Addendum No. 1

Preamble

Lot 1: Revamp of SCADA/EMS Systems

Lot 2: Revamp of Telecommunication System

30. Appendix B, Figure B-2 shall be replaced as below:

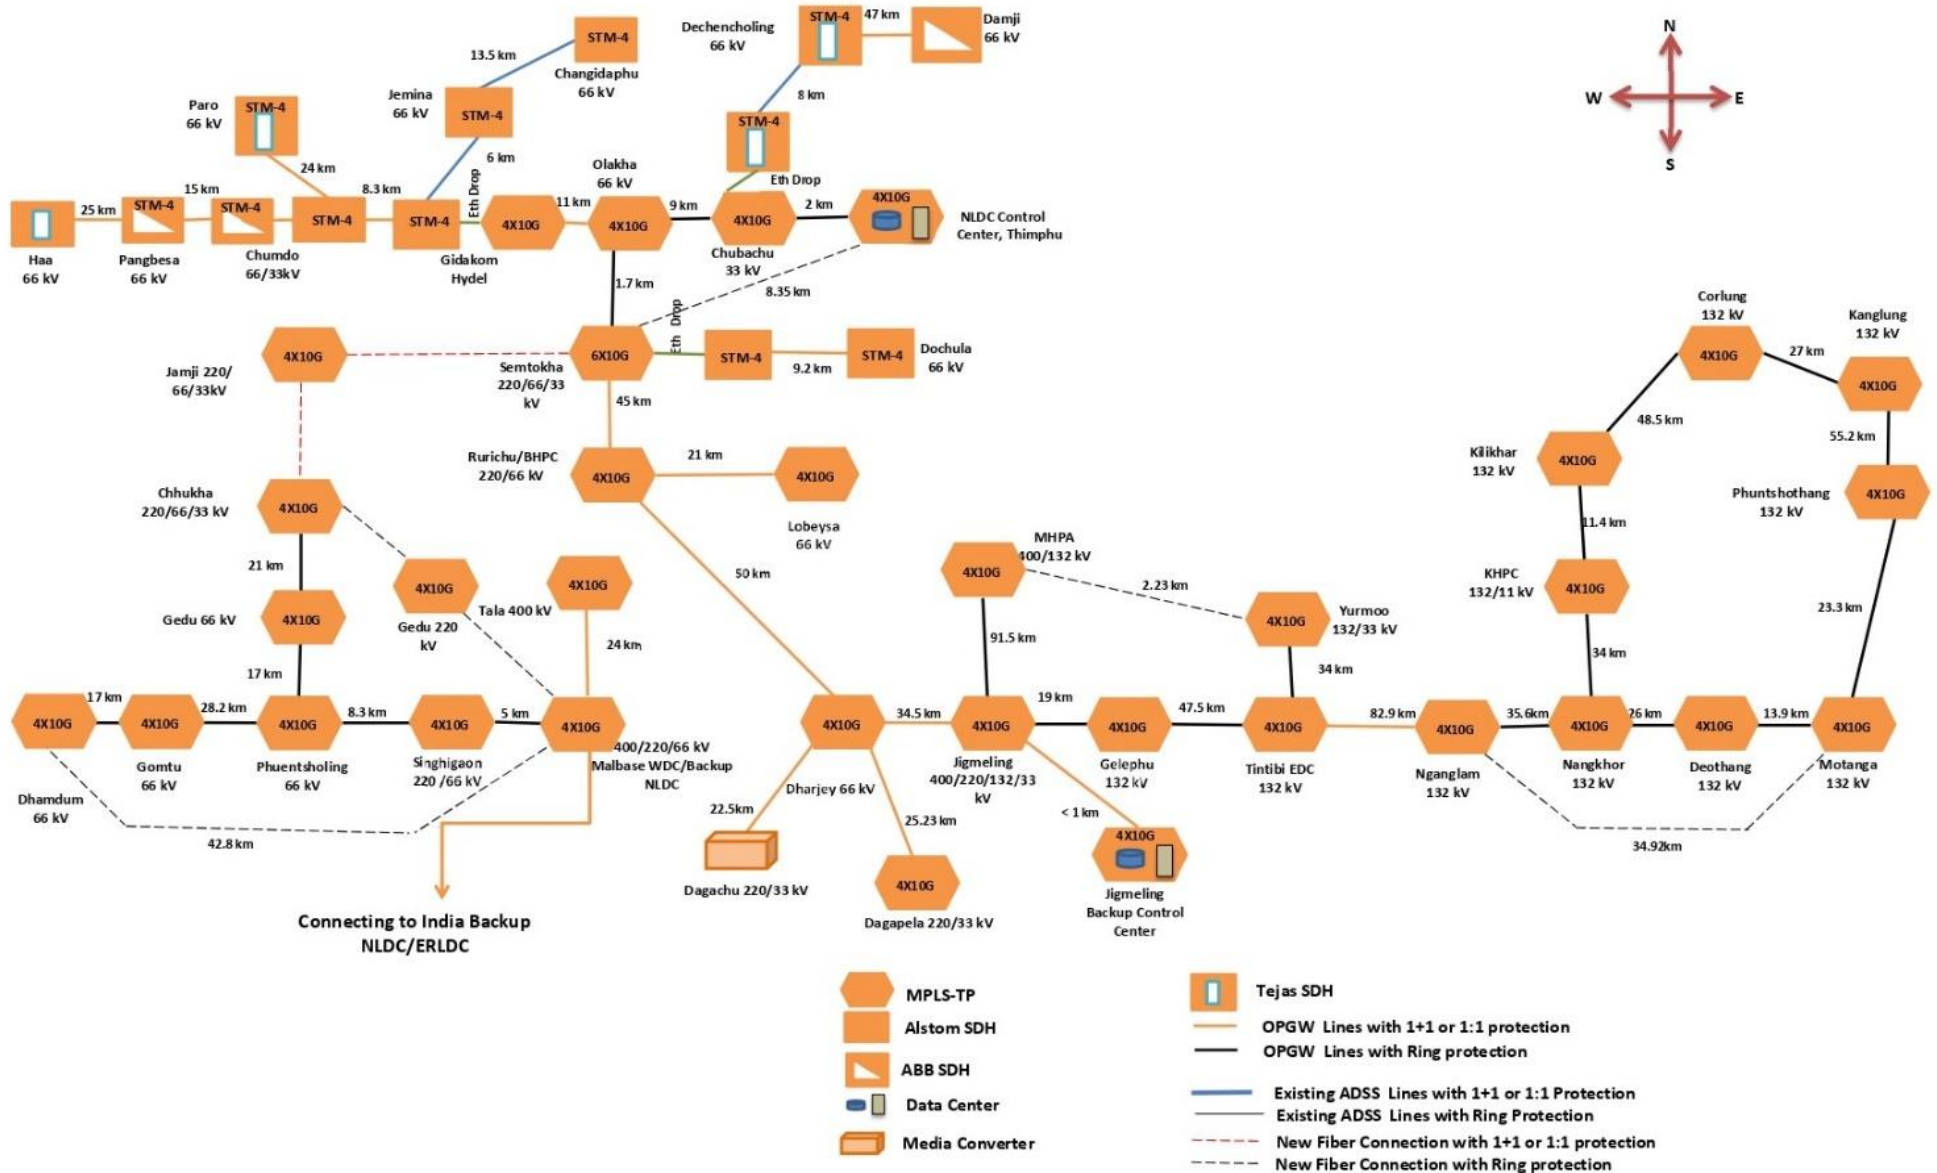
1. The Proposed Network Diagram has been revised to take into account the missing fiber distance between the new lines and to indicate the packet fabric capacity required at each node.

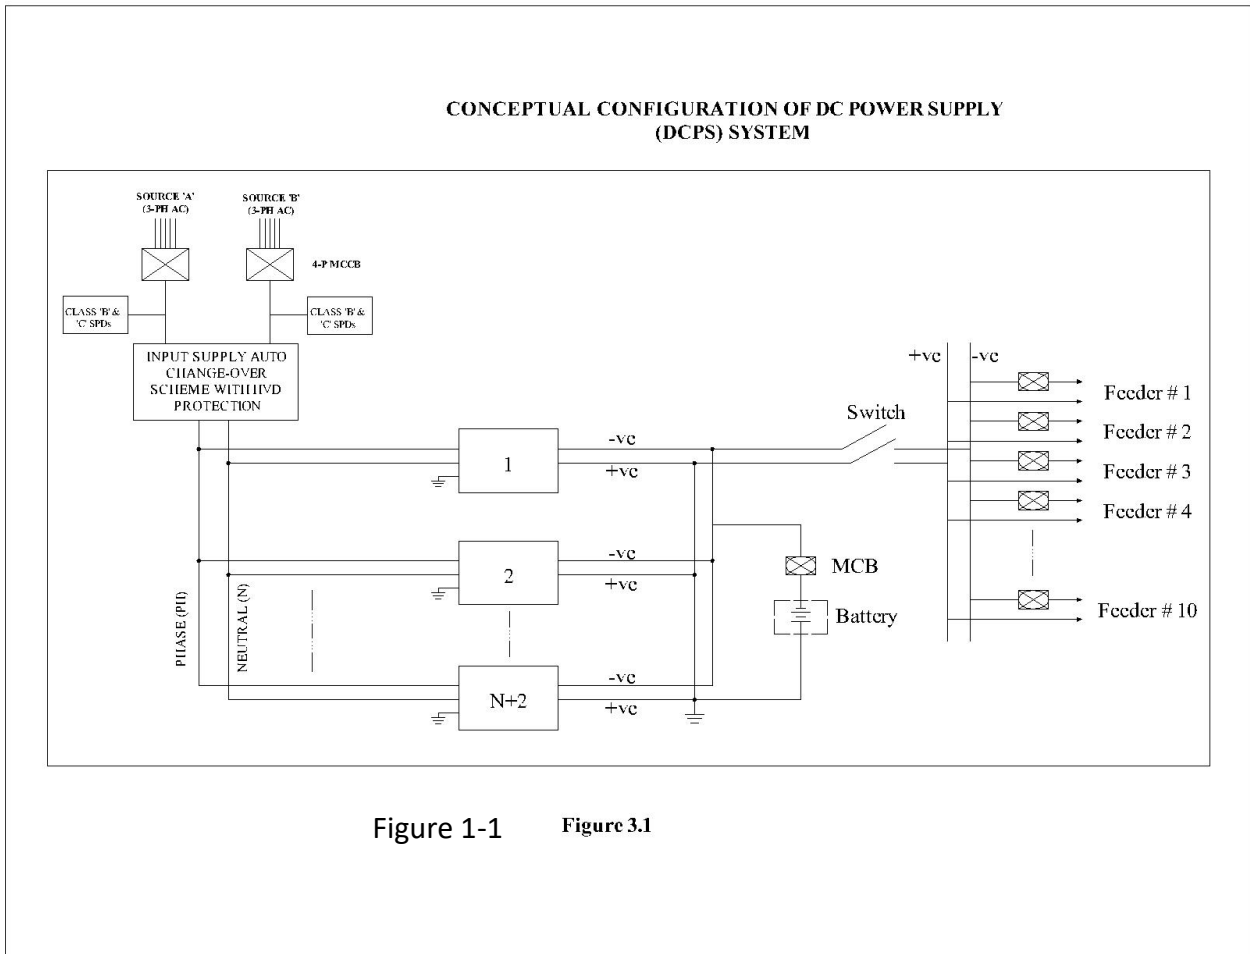
SMPS based DC power supply system is to be used in Auto Float-cum-Boost Charge mode as a regulated DC Power source. DCPS system is to be installed indoors and shall be provided with IP21 panels. The System shall consist of the following:

The basic modules shall operate at specified ratings and conform to requirements stipulated in this specification. The DCPS system shall meet requirement of the latest TEC specification / IEC/BS for other parameters as applicable. The component parts of the equipment shall be of professional grade of reputed manufacturer to ensure prompt and continuous service and delivery of spare parts. The component shall conform to relevant IEC/IS standards. The contractor shall obtain Employers approval of major component before procurement of the same. Conceptual diagram for DCPS is shown in figure 1-1.
